8x931AA, 8x931HA USB Peripheral Controller

Specification Update

August 1998

Order Number: 273140-006

Figure 2. Circuitry for Cold-Boot Errata

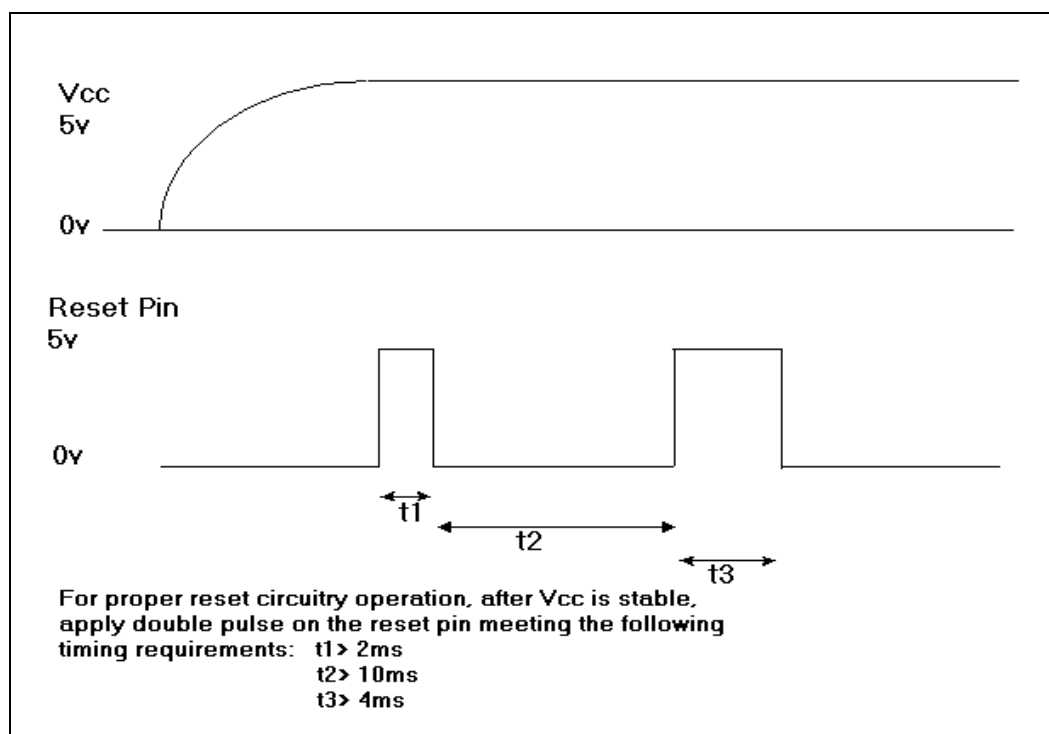
- Problem:** It has been discovered that members of the 8x931 USB Peripheral Controller family may not function after a cold-boot on certain PC systems. Intel has discovered on some PCs, that a small voltage (80mV – 1.0V) is present on the USB +5v connector pin when the system is powered off. This voltage coupled with 8x931 reset sensitivity can cause the 8x931 to fail to enumerate properly after a cold-boot power-on. This issue occurs when the "PC-off" USB supply voltage at the pin is between the range of 80mV – 200mV.

- Workaround 2:** The second method entails the addition of reset circuitry which provides a double reset pulse instead of a single reset pulse at power-on. The reset signal shown in Figure 2 below has been characterized as a possible workaround for the cold-boot errata. Note that this reset pulse can be implemented in various manners. Intel is currently testing several of these methods and will publish them as part of this specification update when testing is completed. Note that use of this or any workaround should be validated by the implementer for given applications.

Figure 3. 8x931HA 64-pin QFP Package

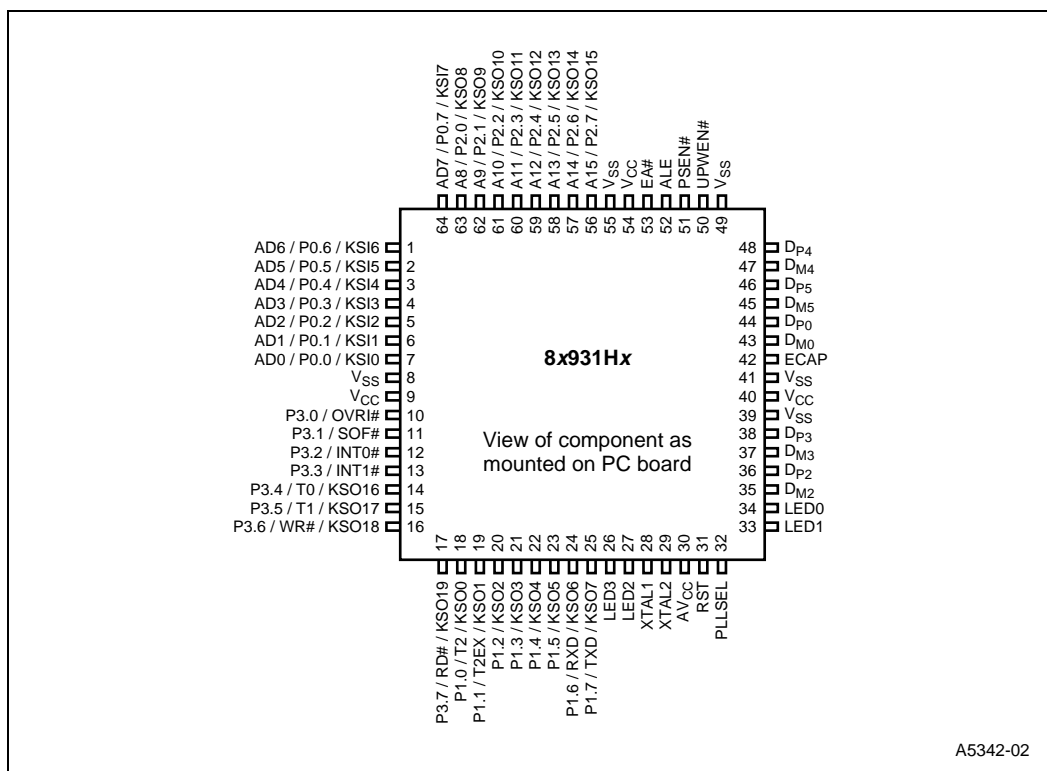
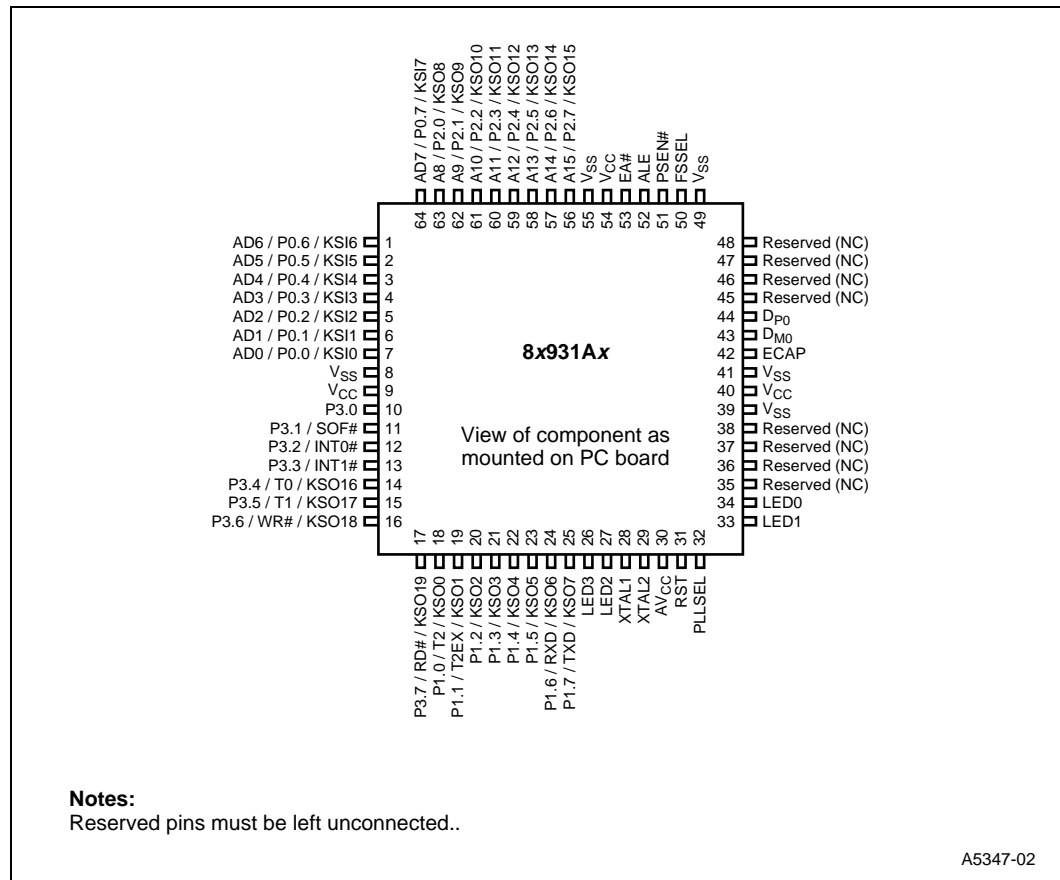
Issue: Figures B-3 and B-4 and Tables B3 and B6 from the *8x931AA, 8x931HA Universal Serial Bus Peripheral Controller User's Manual* have been added below (see Figures 3 and 4 and Tables 1 and 2).
